Our Case Number: ABP-313182-22

Re: BusConnects Clongriffin to City Centre Core Bus Corridor Scheme
County Dublin

RE: Objection to Application for Approval of a Proposed Road - CLONGRIFFIN TO CITY CENTRE CORE BUS CORRIDOR SCHEME – at Artane Cottages Lower, by the National Transport Authority, Case Ref. HA29N.313182

Fig. 5 – Clongriffin to City Centre CBC Scheme – General Arrangement, sheet 15 of 21 (extract)

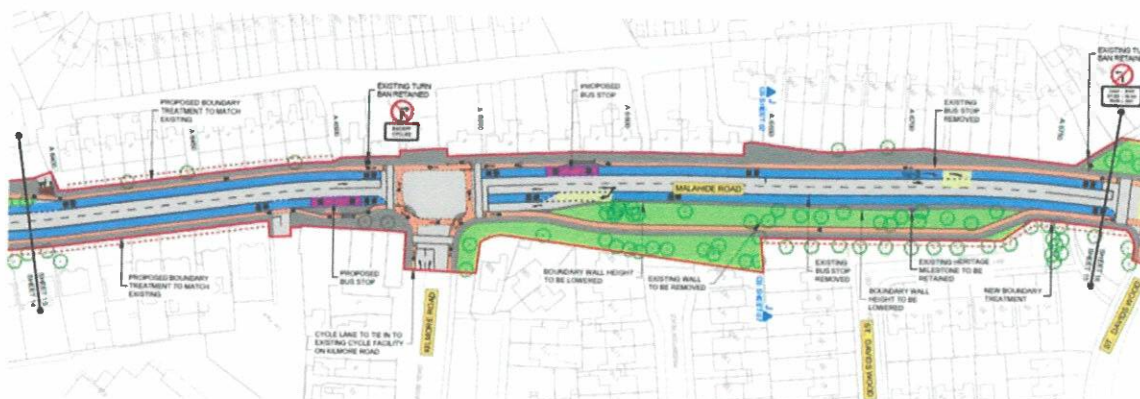
The final drawings lodged with the application (refer fig. 5) are broadly in line with consultation 3, with an apparent slight improvement on the footpath width at Artane Cottages Lower (which had silently been narrowed again between consultations 2 and 3), and further detail shown at the bus stop, refer to item 3 of this submission.

The proposed bus stop is the only one along the entire length of the Clongriffin to City Centre bus corridor scheme located in front of residential property without front gardens, and does not provide space for a bus shelter, nor does it provide adequate footway width to accommodate even a compromised stop.

The bus stop is located less than 25m from the proposed controlled pedestrian crossing to Kilmore Road, at a junction where two bus lines (from West on Kilmore Road, from North on Malahide Road) converge. This will likely lead to busses backing up north and west of the junction, which in turn will lead to busses backed up in front of nos. 7, 8 and 11 Artane Cottages Lower, resulting in increased noise and air pollution, as well blocking out light to those properties. This appears contrary to proper traffic planning and will further reduce residential amenity of the entire terrace, and constitutes a bottle neck along the bus corridor.

In this context, **we object also to the local narrowing of the footpath at the junction to accommodate a right turn hold for the cycle path** (refer Preliminary Design Report, Appendix L, p. 40 of 68) – the proposed layout leaves less than 1.8m footpath, compared to currently approx 3.5m, directly in front of the front door of no. 9 Artane Cottages Lower. This is in direct contravention to the commitment by the NTA to retain the full width of the footpath. In addition to undue increased pressure on the residential amenity of no. 9, it also diverts any pedestrian footfall closer to the front elevations to the terrace than a continuous 3m wide footpath would do. Any right turn arrangement for inbound cyclists onto Kilmore Road could conceivably be accommodated at the much wider footpath in front of no. 10 Artane Cottages Lower, allowing for example a two-way cycle lane on the northern and western arm of the junction, or a revised cycle crossing layout on the southern arm.

If it was not deemed feasible to retain stops 1219 and 1220, the proposed new stop could be relocated: The footpath widens a mere 65m south of the proposed bus stop, at nos. 302 / 300 Malahide Road, to approx. 8m deep. The properties here have front gardens in excess of 15m depth. The location would allow for adequate detailing of the bus stop (again fully in line with details in fig. 7) and appropriate congregation space for people waiting for busses. This, possibly in tandem with a

Fig. 7 – EIA Appendix A4.1 - Preliminary Design Guidance Booklet for BusConnects Core Bus Corridor, figure 34 – Island Bus Stop Arrangement

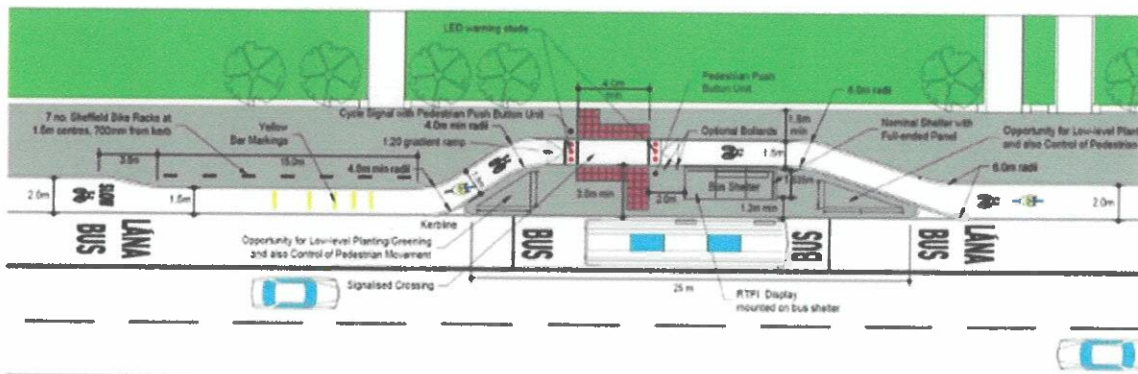
"Island Bus Stops are the preferred bus stop option to be used as standard on the CBC project where space constraints allow." (11.1 Island Bus Stop)

An Island Bus Stop crucially includes a 3m deep island, which provides movement space in excess of 2x2m, a full bus shelter and tactile paving at a designated signalled pedestrian crossing over the 1.5m cyclepath. At Artane Cottages Lower, with the NTA commitment to provide a full width (3.5m) footpath as existing, this would require a min. 8m deep zone between front walls of the cottages and the bus lane.

It is worth noting that the Island Bus Stop Arrangement (fig. 7) as per NTA guidelines allows for these dimensions, but not the applied compromised Shared Bus Stop Landing Zone Arrangement (fig. 8).

Both at the terrace of commercial properties at 25a-g Malahide Road (stop 1219 previously outside 25G Malahide Road) and at 276 – 302 Malahide Road (stop 1220 previously outside 282 / 284 Malahide Road), there would be sufficient depth of the footpath / public realm to introduce island bus stops fully in line with the stated preferred NTA bus stop design, refer fig. 7.

Fig. 8 – EIA Appendix A4.1 - Preliminary Design Guidance Booklet for BusConnects Core Bus Corridor, figure 36: Shared Bus Stop Landing Zone Arrangement (Urban Centres)

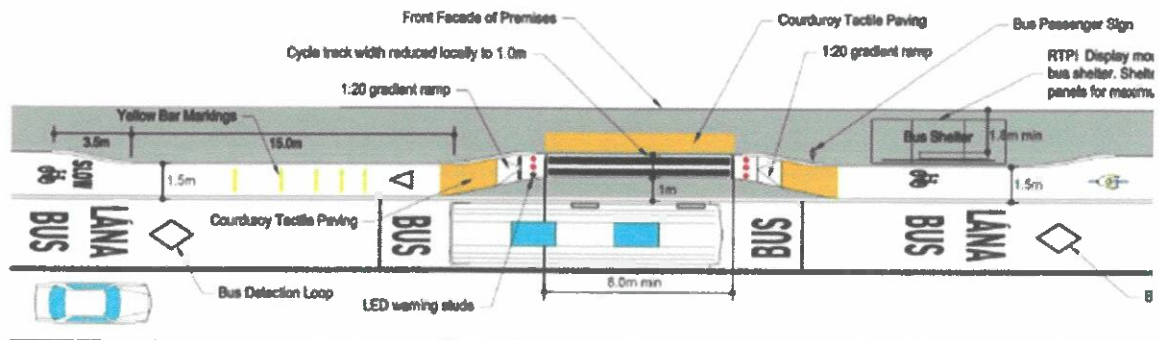
The design in fig. 36 of Appendix A4.1 (here Fig. 8) is quoted as being permissible only in "particularly constrained" situations within "urban centres", which implies it would be outside commercial premises. While the footpath at nos. 5 & 6 Artane Cottages Lower certainly is extremely constrained, there are alternative locations within 65m south or 190m north which are not, refer section 3.4. The site is not located within an urban centre, not even within a suburban one.

Please also note that while the overall dimensions shown in Fig. 8 were used in the proposed stop at nos. 5 & 6 Artane Cottages Lower, the design guidelines at fig. 36 crucially still include a bus shelter close to the stop – bus stops without bus shelters, as proposed at Artane Cottages Lower, are not considered appropriate anywhere in the NTA's own design guidelines. Note that the proposed layout at Artane Cottages Lower also does not follow through on the NTA's commitment to retain the full depth (3.5m) of the existing footpath.

The application of a compromised version of the lowest grade design for the proposed bus stop should therefore be considered unacceptable by An Bord Pleanála.

The above clearly demonstrates that embarking / disembarking of the bus (at all bus stops along the route designed in line with fig. 8 above) will not be possible without an increased risk of accidents between pedestrians / wheelchair users and cyclists. In a physically constrained location as at Artane Cottages Lower, any such accident would occur less than 3m from the front elevations of single storey residential property.
